Illinois Power Company
500 South 2nd Street
P.O. Box 511
Decatur, IL 62525-1805

July 15, 1992

Clinton Power Station
Request to Modify NPDES Permit IL0036919

Also Available On
Aperture Card

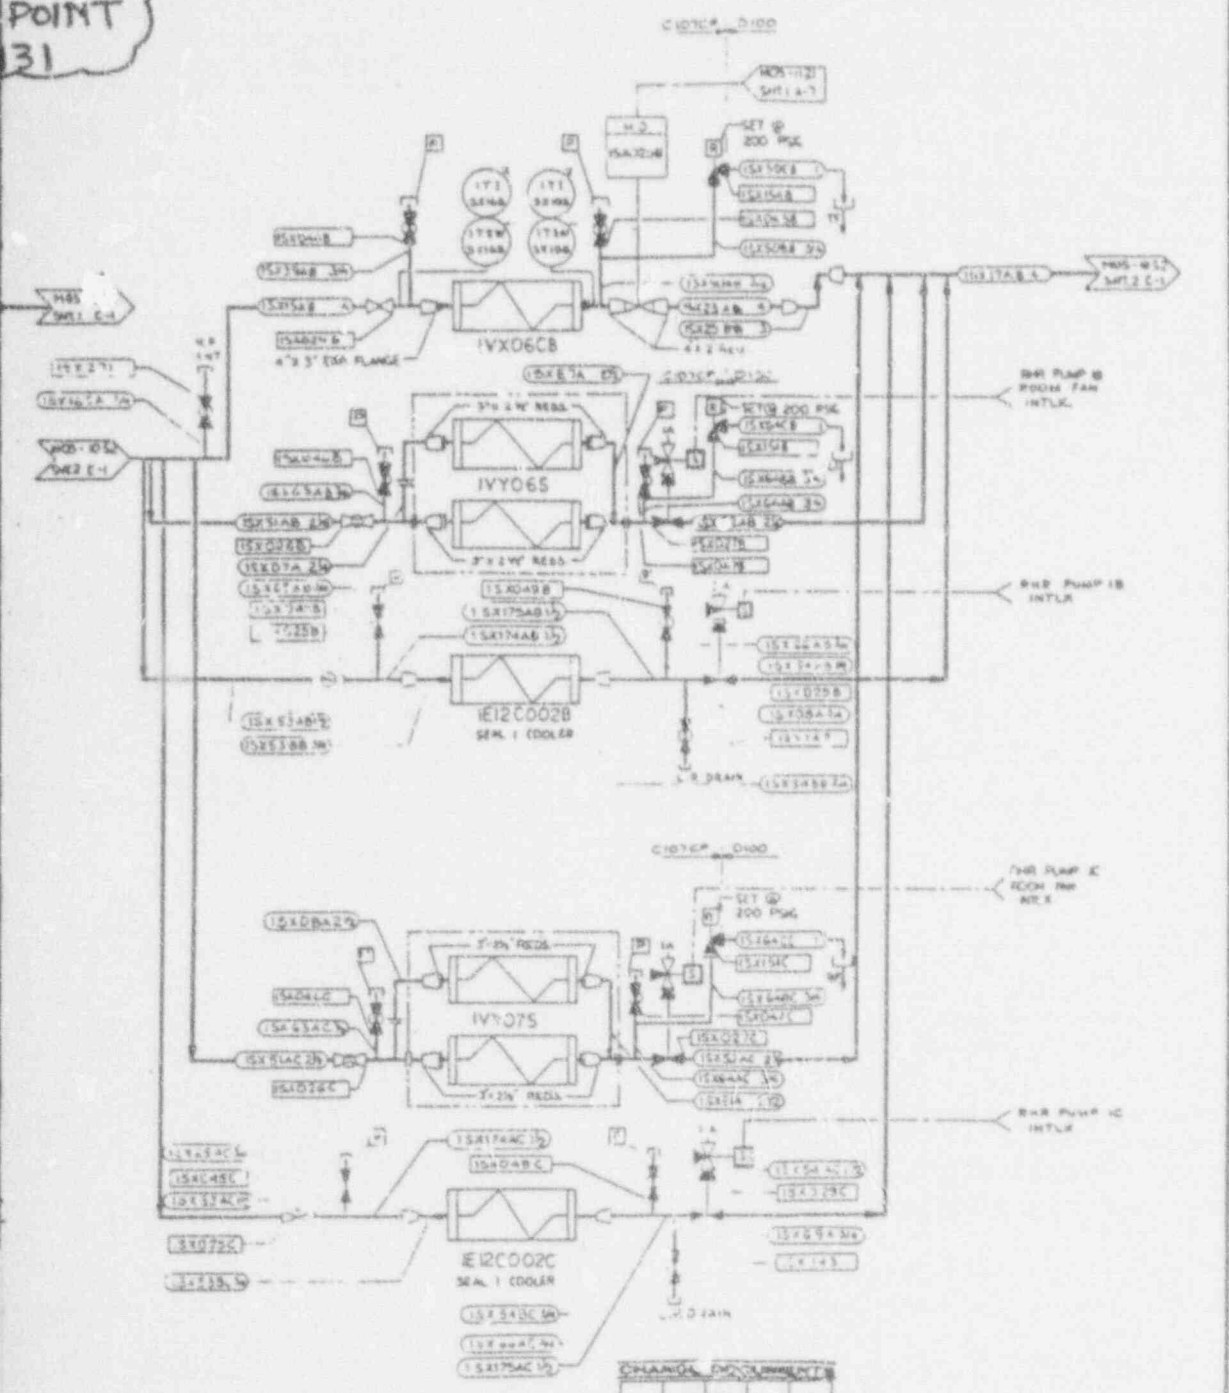
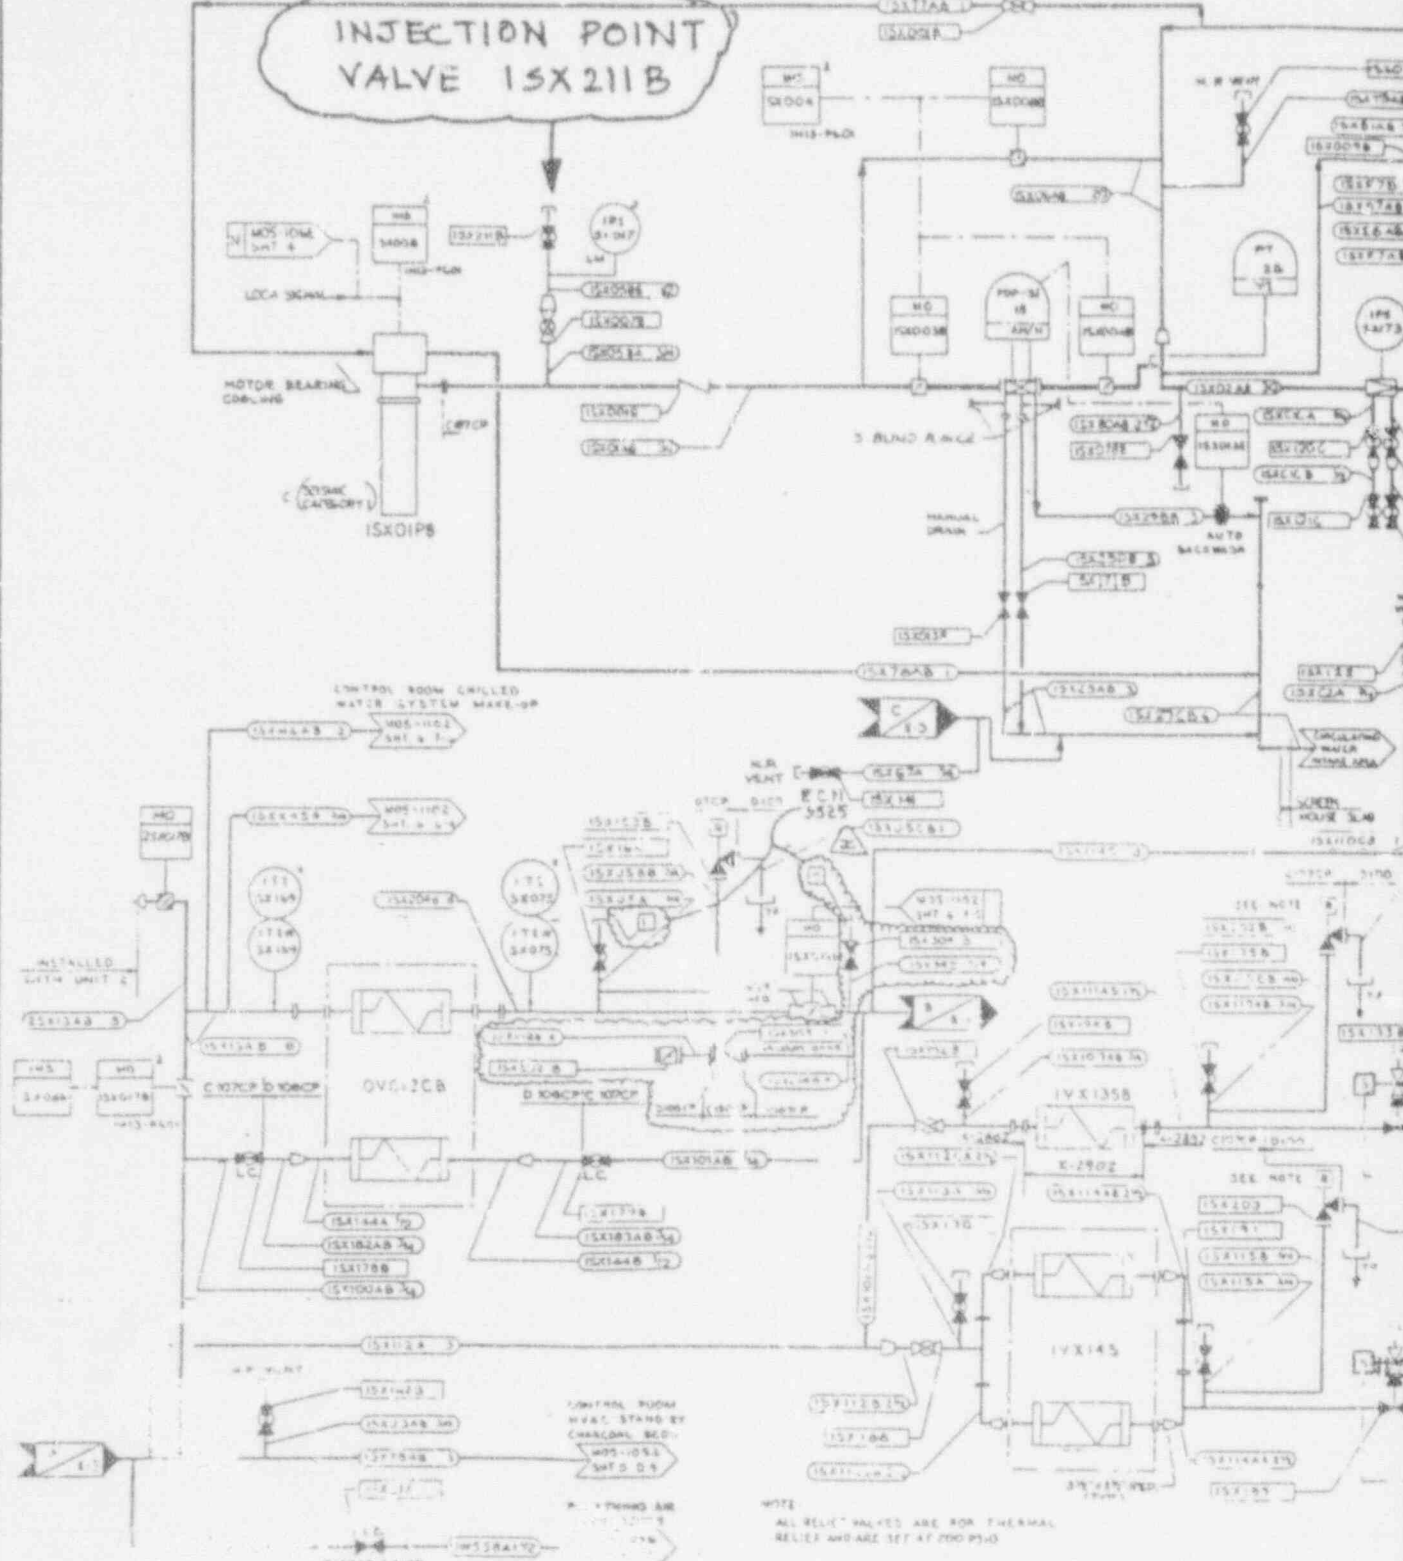
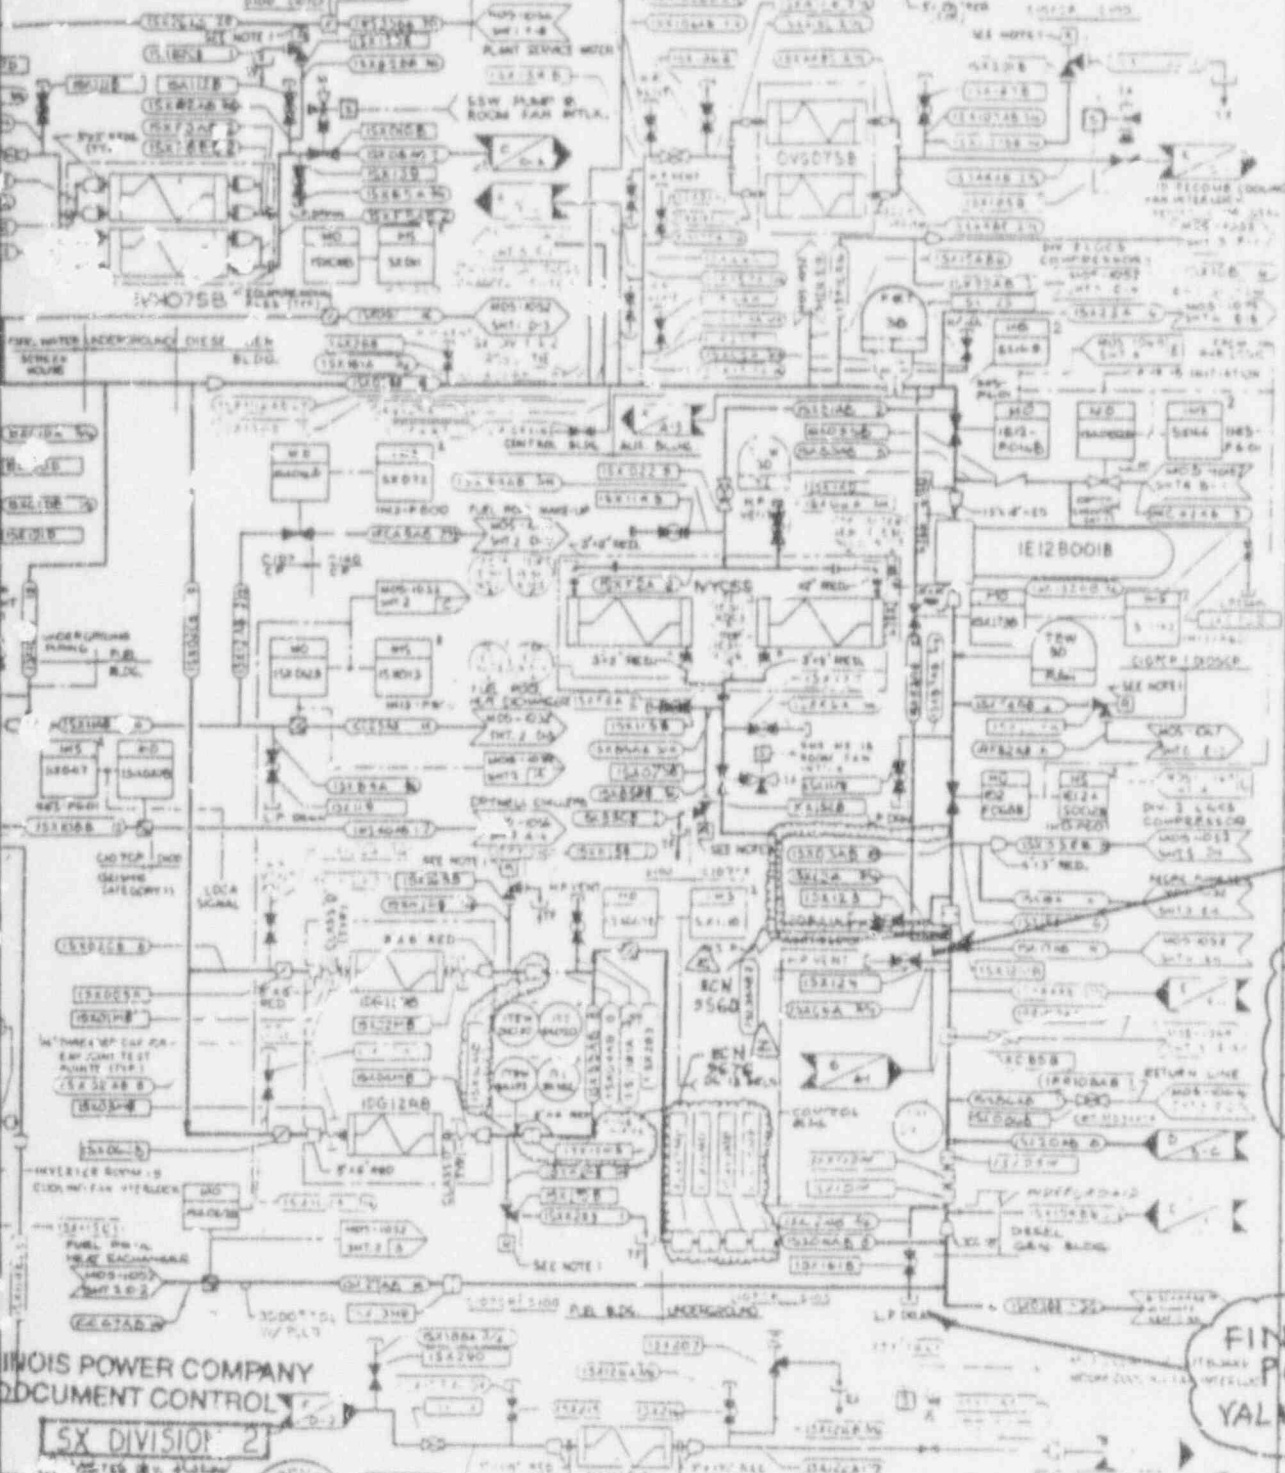
- (g) IP also wishes to notify the Agency of changes in the chemical injection and monitoring points for the SX system treatment program. The exact locations of these points are shown on the enclosed four figures.

DETOXIFICATION
INJECTION POINT,
VALVE 1SX070

FINAL SAMPLE
POINT,
VALVE 1SX168

SAMPLE
POINT
VALVE 1SX059A

INJECTION POINT VALVE 15X211A

SAMPLE POINT VALVE 1SX183A

FINAL SAMPLE VALVE 1SX161A

SAMPLE POINT
VALVE 15X183B

DETOXIFICATION
INJECTION
POINT
VALVE 15X124
